AGENDA
Cascade Charter Township Zoning Board of Appeals
Tuesday, December 12, 2017
7:00 pm
Cascade Library Wisner Center
2870 Jacksmith Ave. SE

STAFF REPORT: Case # 17-3423
REPORT DATE: November 10, 2017
PREPARED FOR: Cascade Charter Township Zoning Board of Appeals
MEETING DATE: December 12, 2017
PREPARED BY: Steve Peterson, Planning Director

STAFF REPORT: Case #17-3426
REPORT DATE: November 30, 2017
PREPARED FOR: Cascade Charter Township Zoning Board of Appeals
MEETING DATE: December 12, 2017
PREPARED BY: Steve Peterson, Planning Director

LAKE MICHIGAN CREDIT UNION - GLENWOOD
 Site Layout Plan
 PART OF THE NORTHWEST QUARTER, SECTION 36, TOWNSHIP 35 NORTH, RANGE 18 WEST, COUNTY OF KENT, MICHIGAN

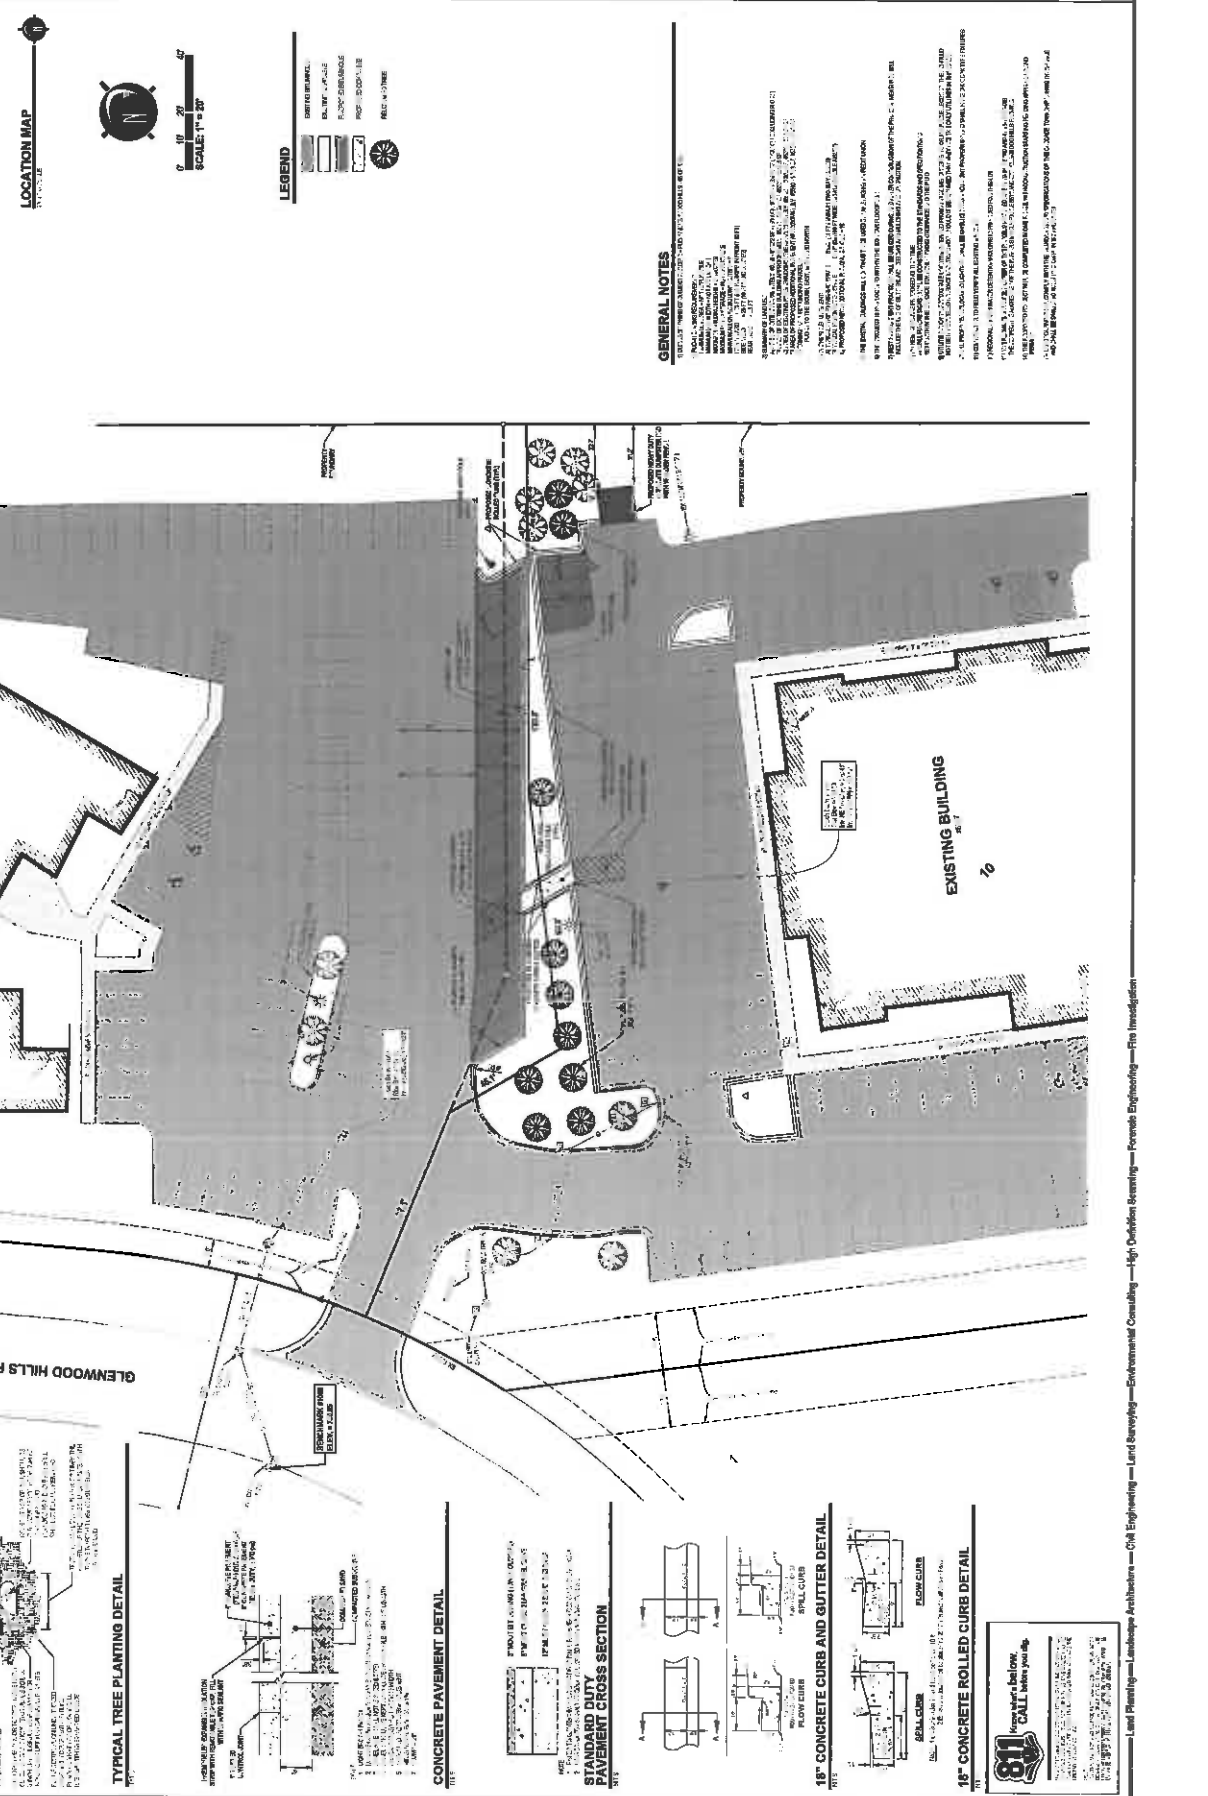
1. The applicant is requesting approval from the ZBA to allow an expansion of a parking lot that would result in an insufficient bufferyard between the parking lot and the property lines.

2. As a result of their actions it would place two properties into non-compliance. 5519 Glenwood Hills and 5537 Glenwood Hills.
3. The property is zoned as a part of the Glenwood Hills office park project. This PUD was done in 1986. The buildings and parking were developed in compliance with those requirements.

4. The property at 5519 Glenwood Hills was built in 1989 and the property at 5537 Glenwood Hills was built in 2001.
5. The landscaping requirements in the PUD allow for flexibility by not dictating the bufferyard size. However, they are moving the property lines which would not have been contemplated. Their proposal not only reduces the distance between the property line and the parking it also removes several trees. All of which was part of the prior approvals.

6. A normal bufferyard in the office area would be 25 feet between parking lots and property lines. The existing properties have between 10 and 25 feet. They are be proposing 0 and 10 feet.

7. I don't believe the intent with allowing the flexible approach to the bufferyard would have allowed this reduction in size and plantings.
8. Both properties are owned by the Lake Michigan Credit union. However, this does not change the bufferyard requirement

10. Any expansion of the parking lot will also require site plan approval.

Staff Recommends Denial of the requested variance.

SITE PLAN

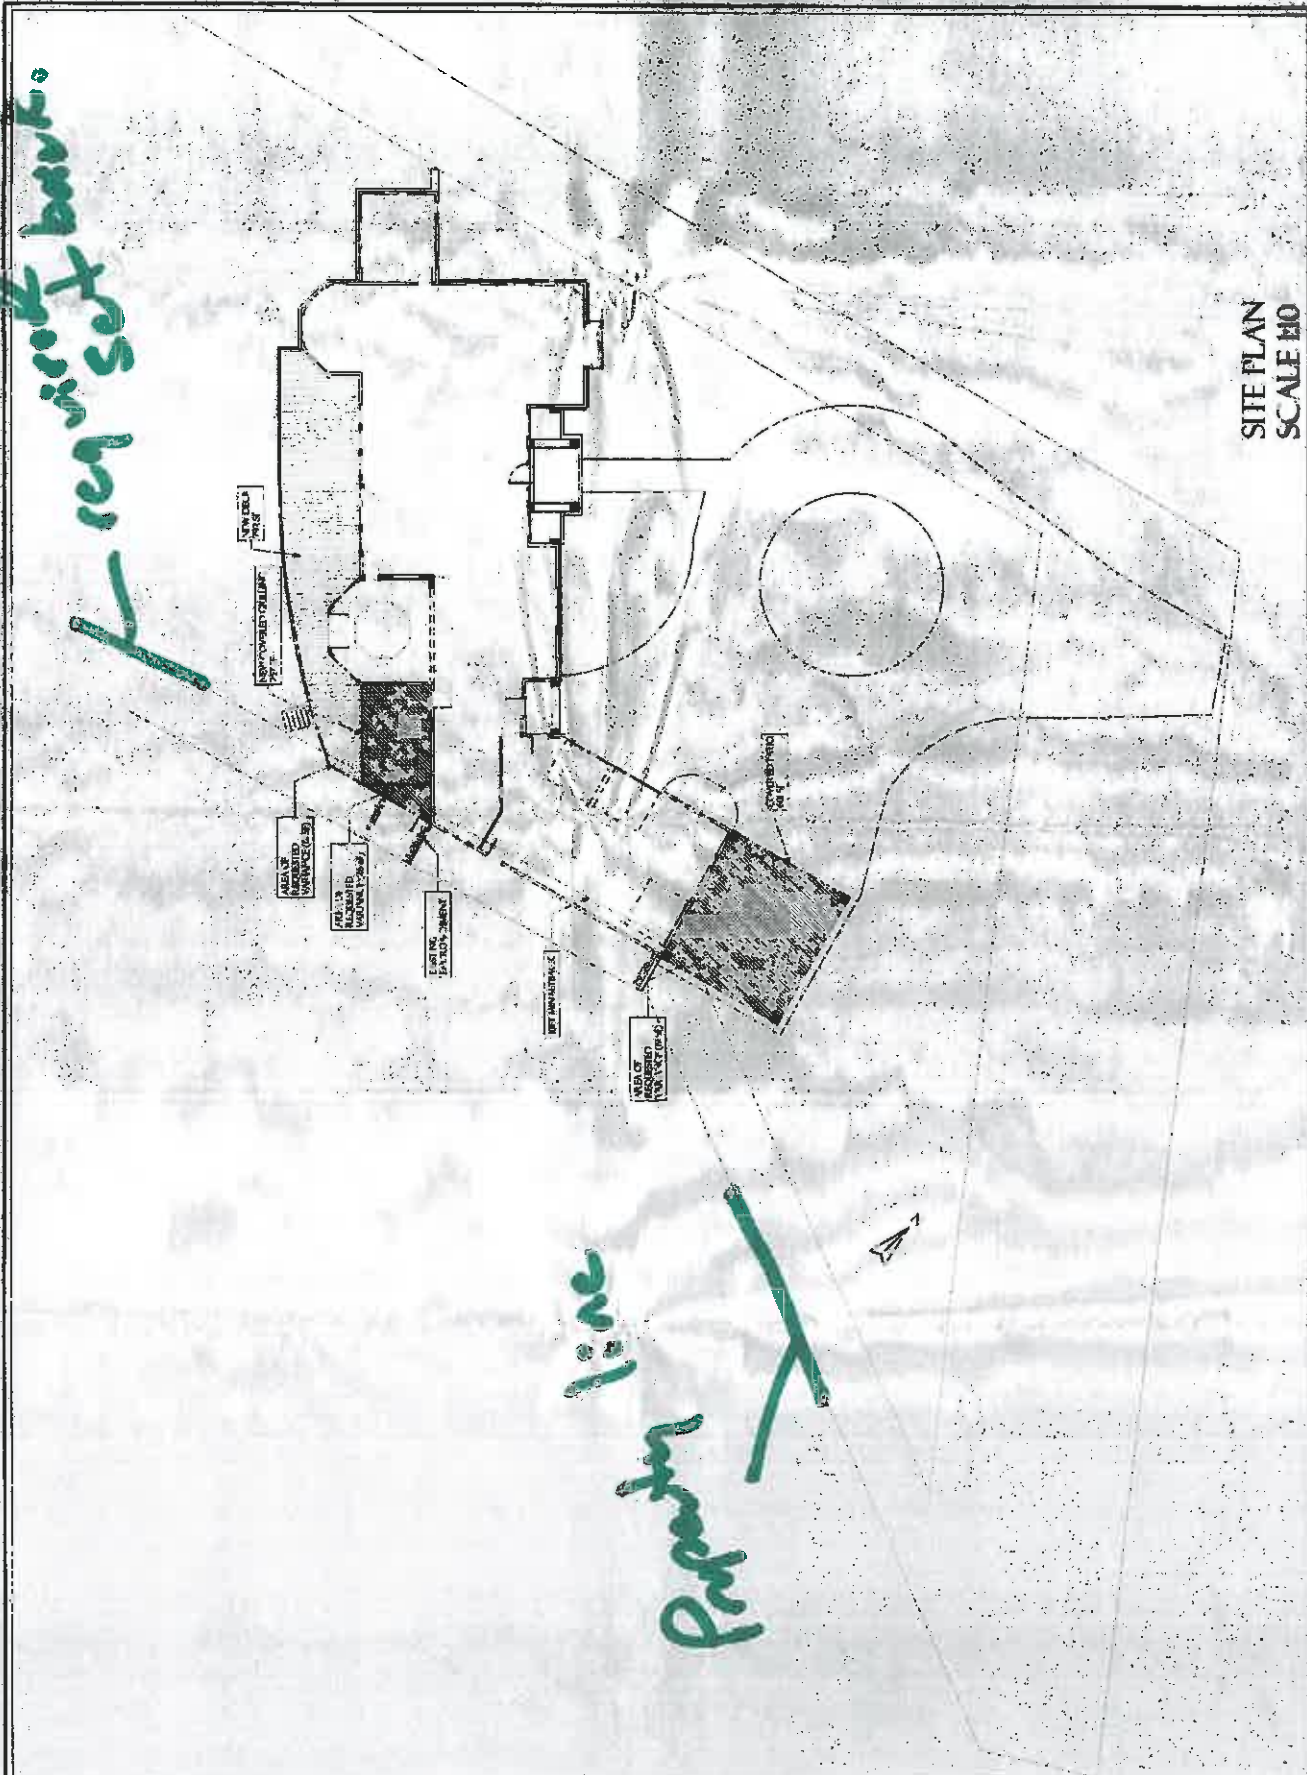
- 1) The home on the property is setback about 7 feet from the side property line .
- 2) The home was built in 1965. I was not able to find a record of a variance.
- 3) The homeowner would now like to put an addition onto the house and continue the same 7 foot sideyard setback. This results in three areas that would encroach into the required 10 foot setback.

- 4) The lot is irregular shape and the home is built on an angle which appears to contribute to the problem.
- 5) The addition would allow a covered patio, deck and covered grilling area. Each of these areas has a small amount of that encroaches into the setback. Covered patio encroaches about 19 sq ft into the setback. The deck about 12 sq ft. the covered grilling area about 26 sq ft.
- 6) The home closest to these additions is located about 150 away from the common property line.
- 7) In situations like this where we have a non-conforming setback we require that any new addition meet today's requirements, thus the need for the variance. In cases where we have granted variances like this we have typically had them not increase the amount of non-conformity. This variance would not increase the non-conformity.

The existing home encroaches in the side yard setback by 3ft at the garage corner and 2ft at the western most corner of the house. The proposed covered patio and covered grilling area will keep in line with the existing exterior in order to keep the renovation compatible with the current home condition, design and appearance.

The covered patio area in question encroaches on an angled portion of the site boundary by 3 ft (19 sf total). See site plan for further information. The covered grilling area condition is similar to that of the covered patio and encroaches by 2 ft.

Staff recommends approval of a variance to allow the additions provided it is not closer than what the current home is.
